MEMORANDUM

PROJECT: Redland Road from Crabbs Branch Way to Needwood Road
CIP Project No. 500010

REVIEW TYPE: Mandatory Referral No. 01813-DPW&T-1

RECOMMENDATION: APPROVAL WITH COMMENTS TO DPWT

Proposed Plan showing bike route

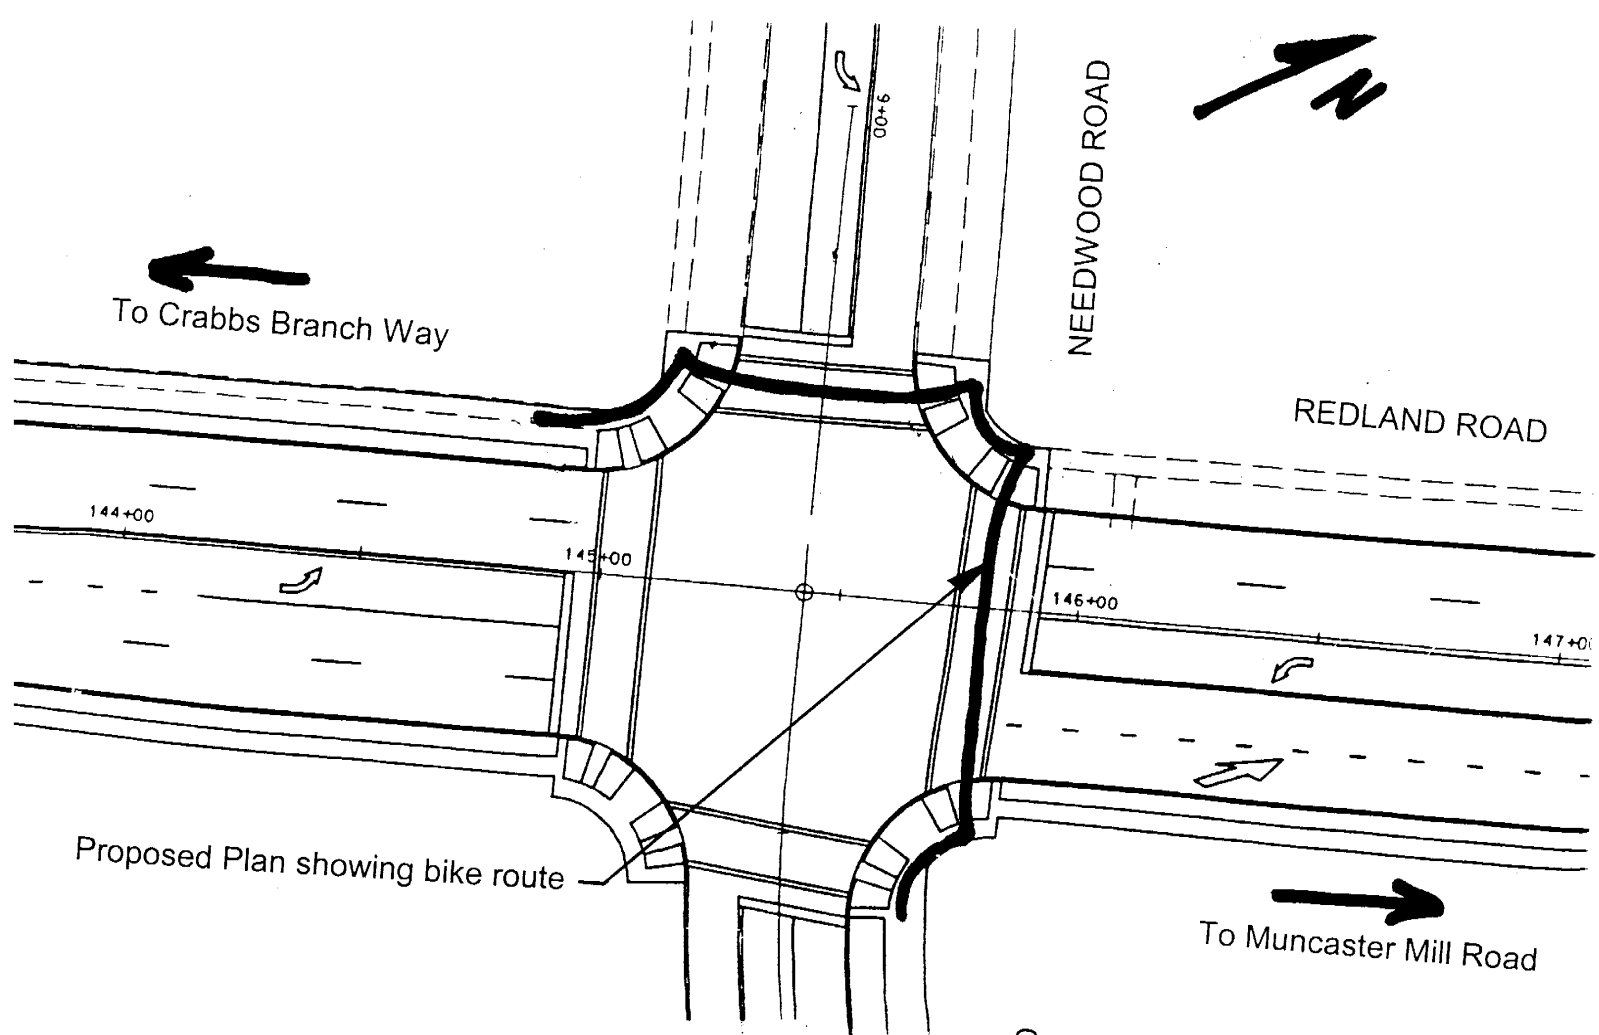
There is an offset in the alignment of the eastbound through lanes of Redland Road at the Crabbs Branch Way intersection that could be reduced by shifting the lanes on the west leg of the intersection four feet to the south. Such a shift would provide the opportunity to create an eight-foot-wide curbed median with a refuge to accommodate bicyclists and pedestrians. Since the Crabbs Branch Way path shifts from the east side of the road to the west side at this intersection, this appears to be the best place to accommodate this change for path users. There is a large area that is proposed to be striped out of the pavement to create the left-turn bay. **Staff recommends that a median be constructed between the Metro Station entrance and Crabbs Branch Way and be landscaped where possible.** (See Attachment 5.)

While the Shady Grove Sector Plan update intends that bicyclists coming from the east go north along Crabbs Branch Road and enter Shady Grove Metro Station at a new crossing location, a short section of path is proposed between the Metro driveway and Crabbs Branch Way. Staff believes that this would provide a useful alternative route to the station. Since this segment would be in the more urban Metro station area, **staff recommends that the path between the Metro driveway and Crabbs Branch Road be constructed of concrete rather than asphalt.**

The proposed path on the east side of Needwood Road would cross the east leg of the Redland Road intersection where users can be provided more time to cross. The design of the bike crossing needs to be improved in two ways, however. The handicap ramps need to be eight feet wide – the width of the path. Also, an easily navigable route is needed, unobstructed by ramps. Staff recommends that at least an eight-foot path width be provided outside the ramps in the southeast, northeast and northwest quadrants of the Needwood Road intersection. Attachment 6 shows the proposed condition on top and staff's recommendations on the bottom.

Staff recommends that a design similar to the one recommended above for Needwood Road be used to ensure that bicyclists have a relatively flat route while making the switch from one side of the road to the other and that handicap ramps are

sized to accommodate bikes (see Attachment 5). It appears that the safest way to cross path users at this intersection would be on the west leg via the refuge recommended above.

Attachment 7

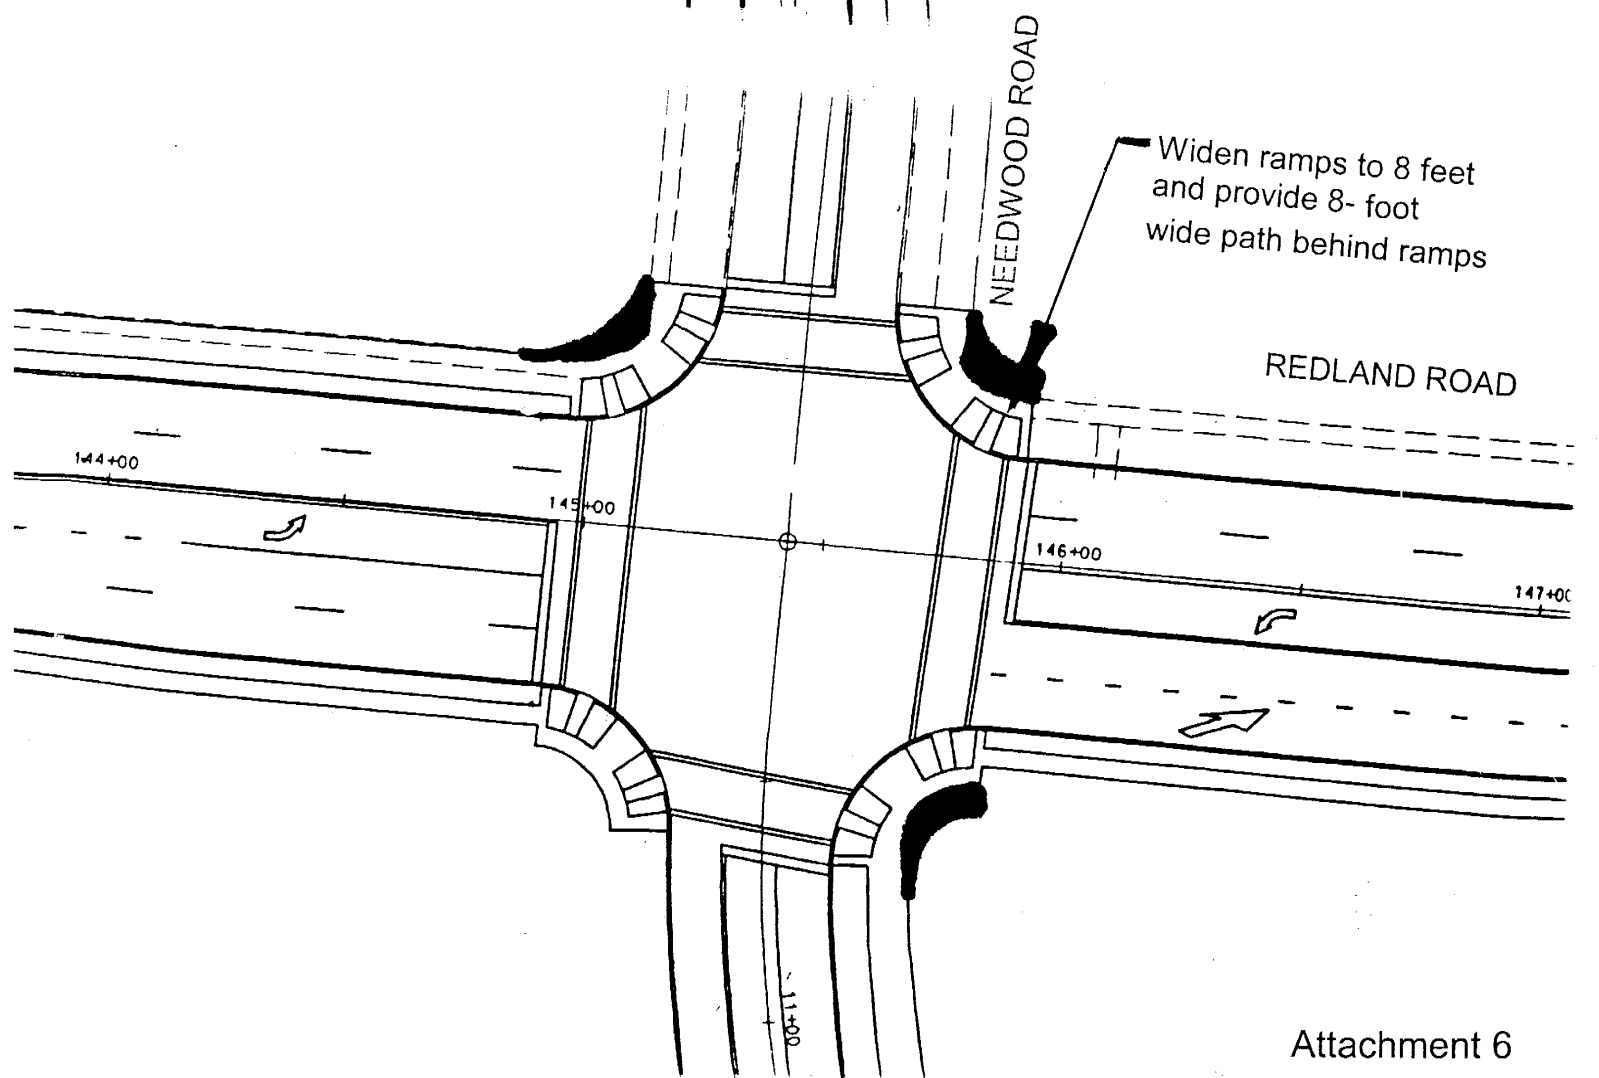
The proposed project will impact Crabbs Branch Park, which abuts the southeast corner of the Crabbs Branch Way/Redland Road intersection (see Attachment 7). This work will require a park construction permit. A note must be placed on the plans stating, "No staging for construction and no storage of materials or equipment will be allowed on park property without prior approval from Park Manager and/or MNCPPC-Inspector."

The project would require the taking of approximately 3,650 square feet mostly along the east side of Crabbs Branch Way. As noted above, staff recommends that the landscape panel between the relocated sidewalk and the curb be increased by just over five feet so that shade trees can be retained. This would increase the park impact by about two to three thousand square feet.

The trees on park property along Crabbs Branch Way that are within 30 feet of the limit of disturbance must be protected during construction with a tree protection fence.

Staff-recommended extension

Raised crosswalk to be provided
